## TECHNICAL MEMORANDUM

Date:	May 28, 2025
To:	Matt Mawer, NW Lifestyle Homes
From:	Deb Powers, Senior Arborist
Project Name:	Mercer Island Hackett Tree Protection Plan
Facet Number:	2312.0315.01
Permit Number:	2502-129

# Arborist Report Addendum: Permit Review Response

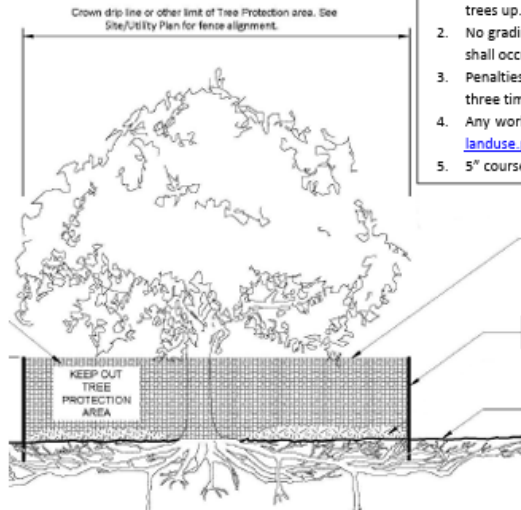
**4. Comment: Suggestion to update the tree protection fence standard.**

Response: Use the current fence standard provided in Figure 1.

Install tree protection fence at recommended locations prior to the commencement of construction that shall remain in place for the duration of the project. All construction activities shall be conducted outside of the fenced areas. If construction sequencing changes, additional tree protection fencing may be required to prevent tree damage. Fencing shall meet City of Mercer Island standards (Figure 1).
